ROLLING MEADOWS CHANNEL & FLOODPLAIN MODIFICATION

EPC STORMWATER REVIEW COMMENTS
IN ORANGE BOXES WITH BLACK TEXT

PCD-ENGINEERING REVIEW COMMENTS
IN BLUE BOXES WITH BLUE TEXT

60% DESIGN PLANS
JANUARY 2023

| PLAN AND PROFILE STA. 5+00 - 20+00 | | | |

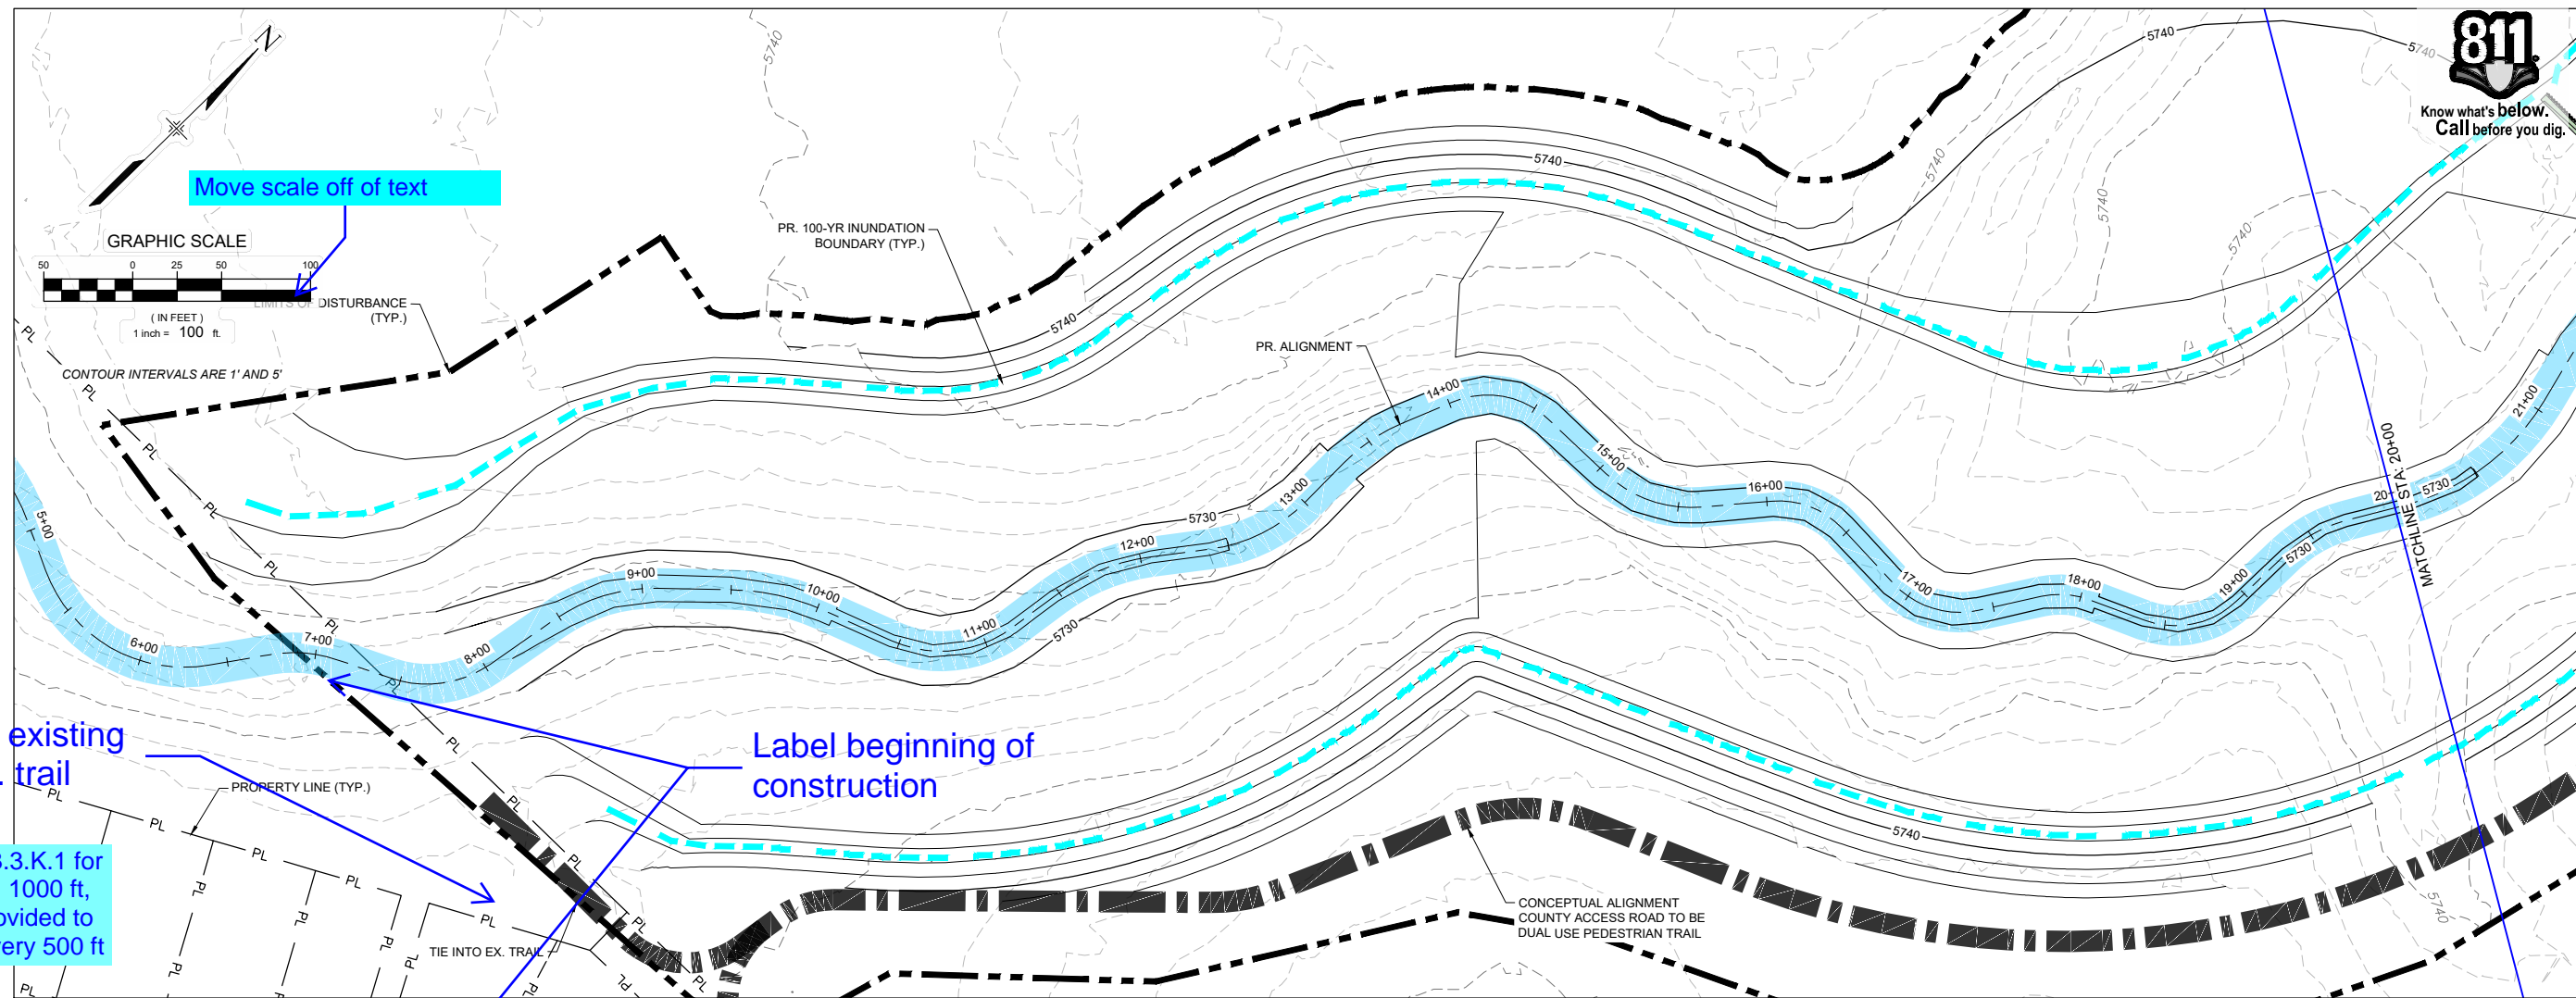
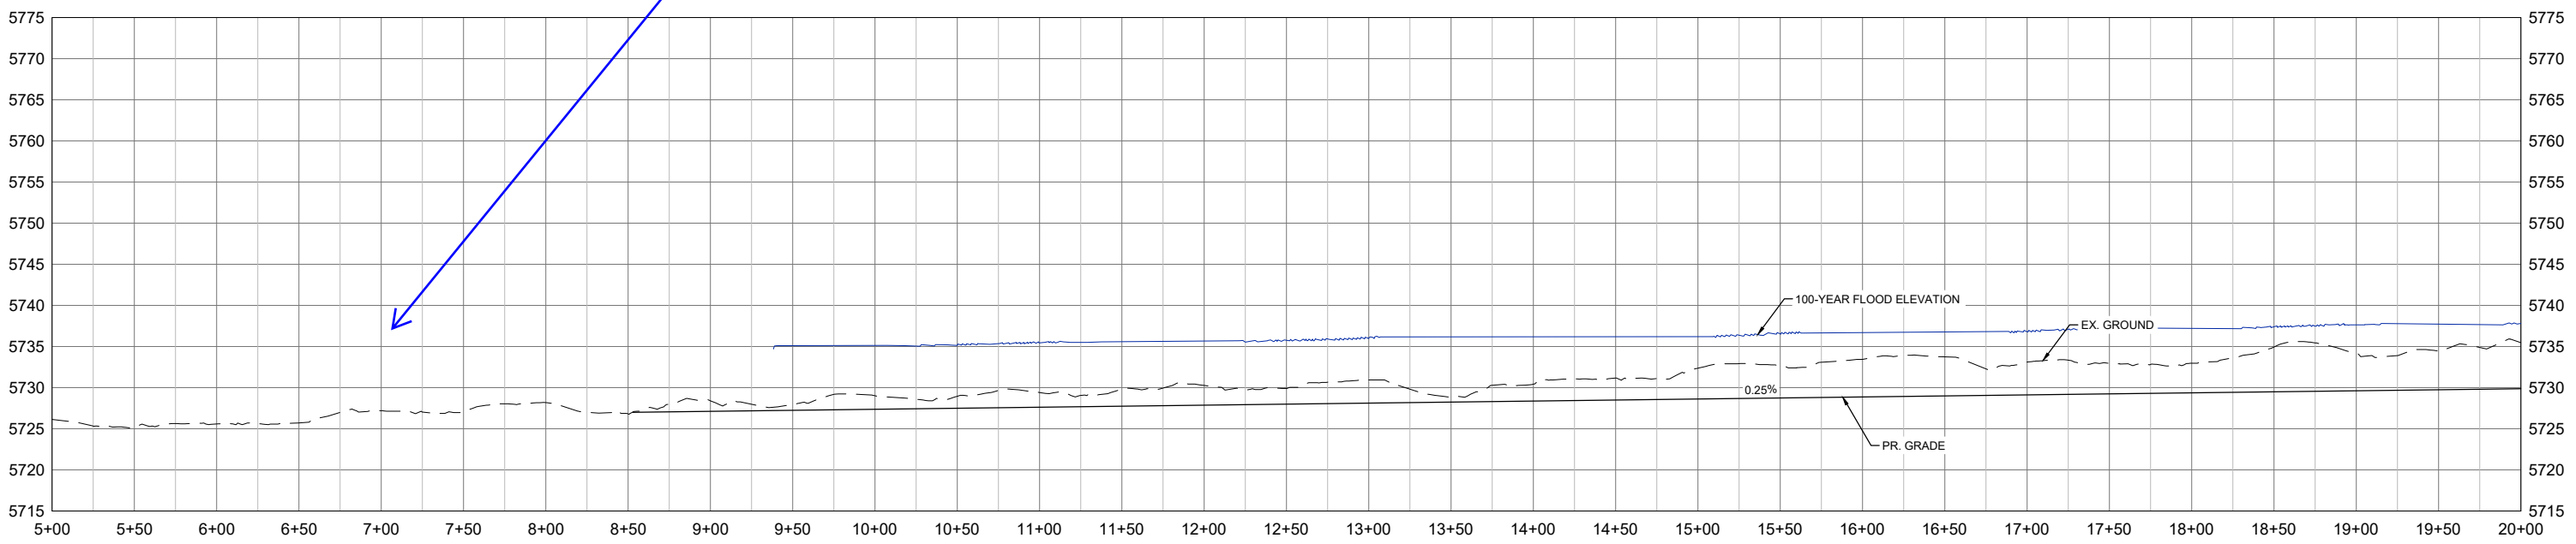
Move scale off of text

Show existing maint. trail

Label beginning of construction

Per ECM Section 3.3.3.K.1 for channels longer than 1000 ft, ramps need to be provided to bottom of channel every 500 ft

PLAN AND PROFILE
STA. 48+00 - 63+00

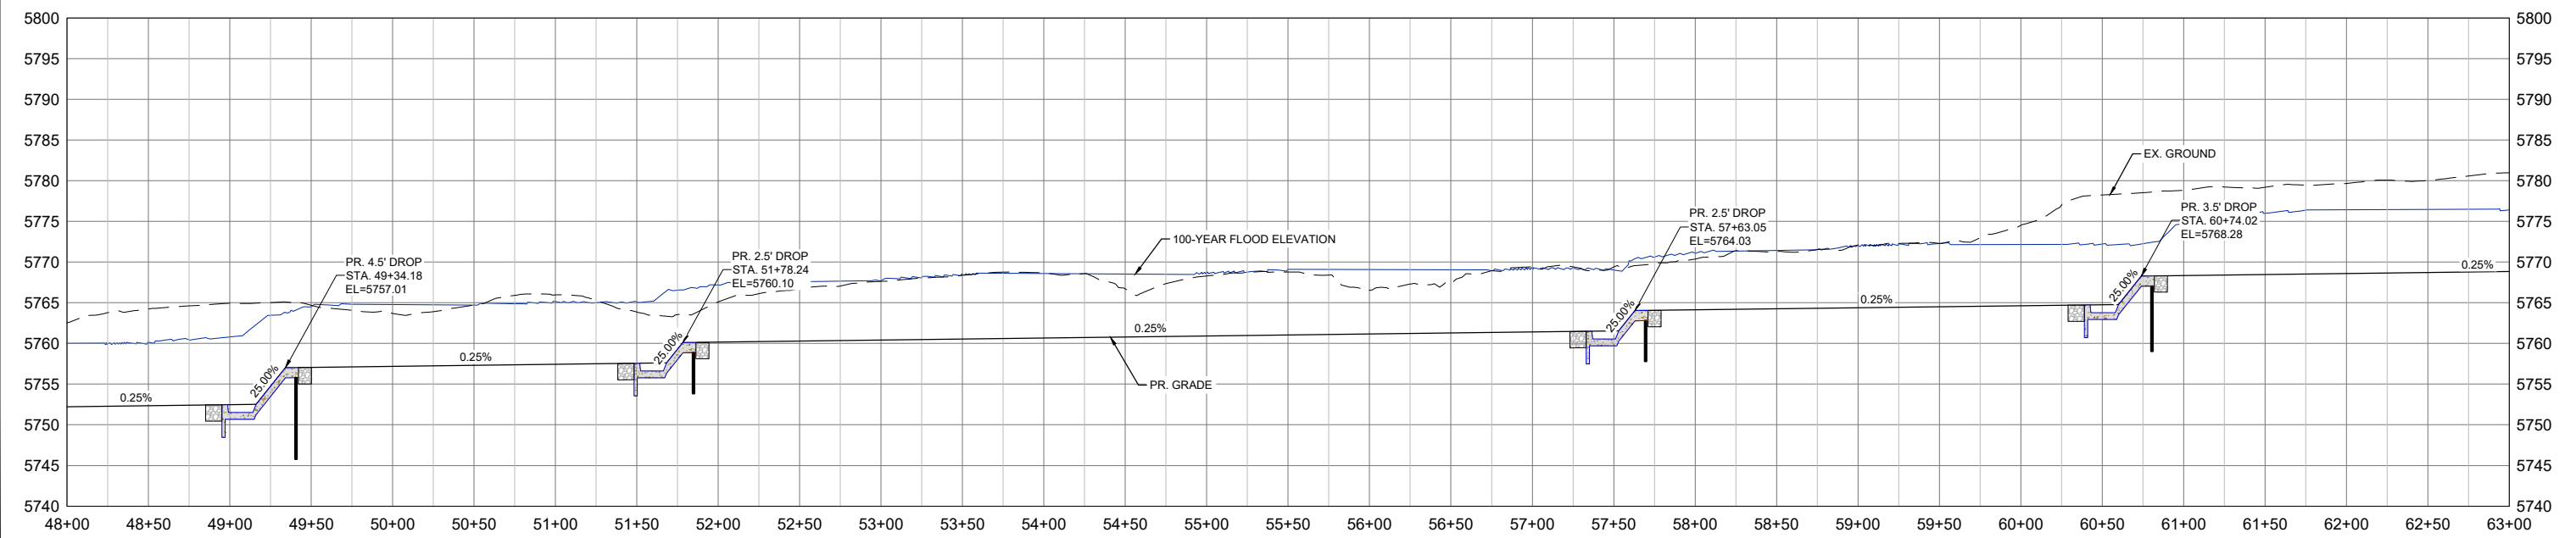
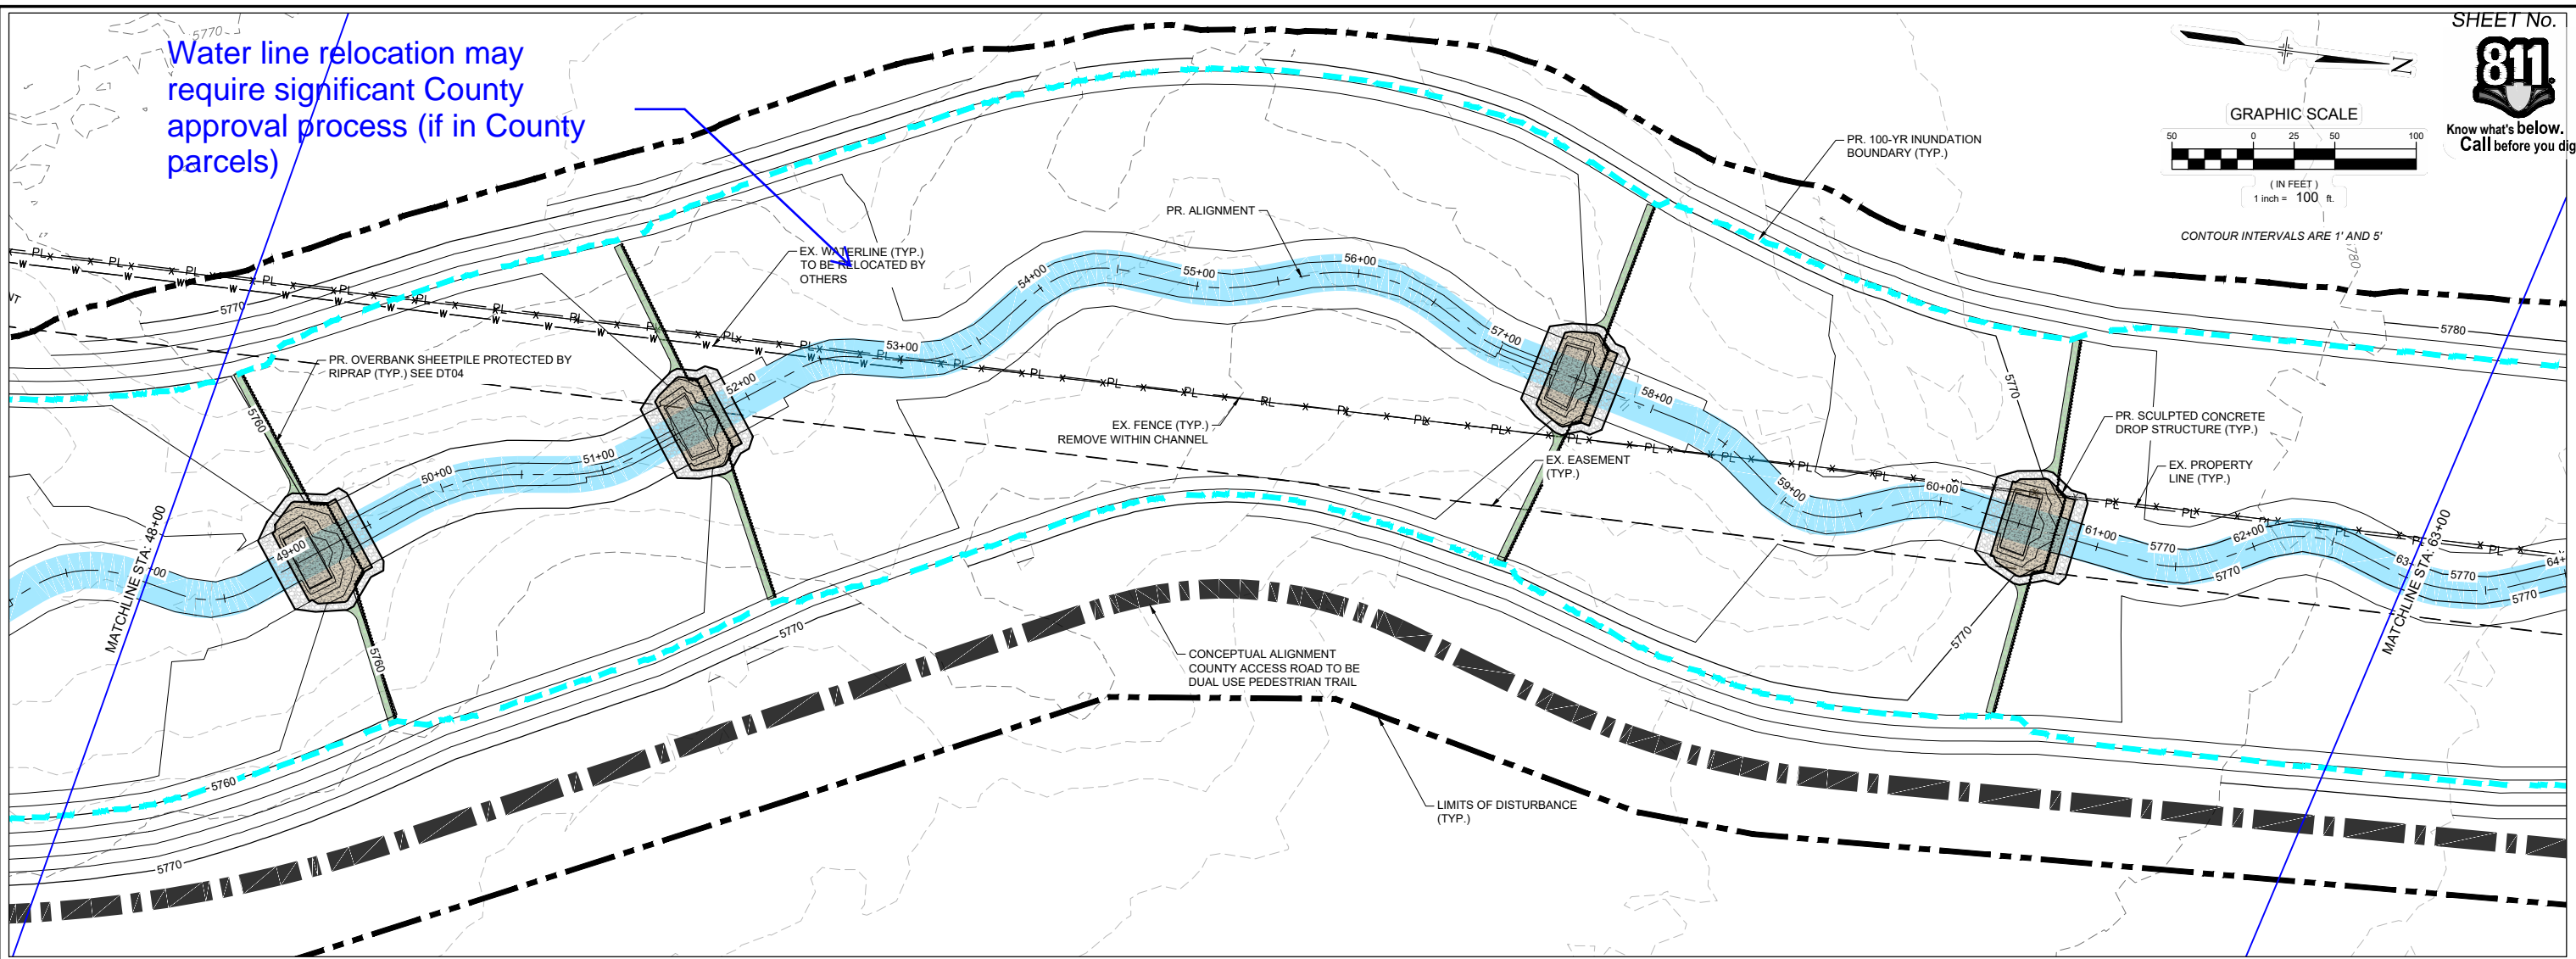
Water line relocation may require significant County approval process (if in County parcels)

C-C' PROFILE ALONG PROPOSED CONSPAN CULVERT
NOTE: FOLLOWS THE PR. CHANNEL ALIGNMENT
HORIZONTAL SCALE: 1" = 80'
VERTICAL SCALE: 1" = 20'

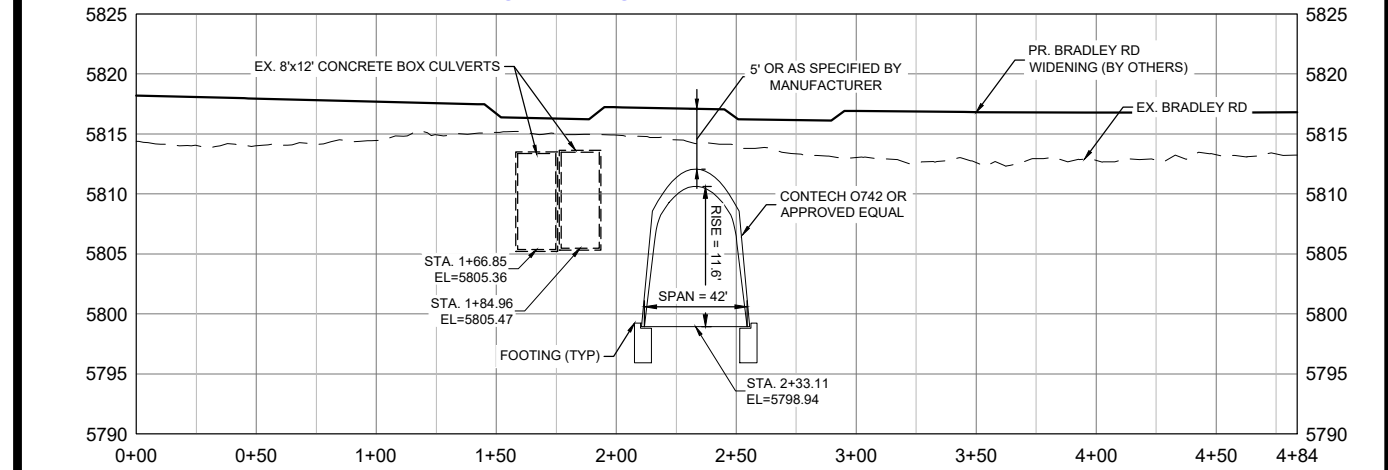
more detail will be needed on the drop for the flow coming through
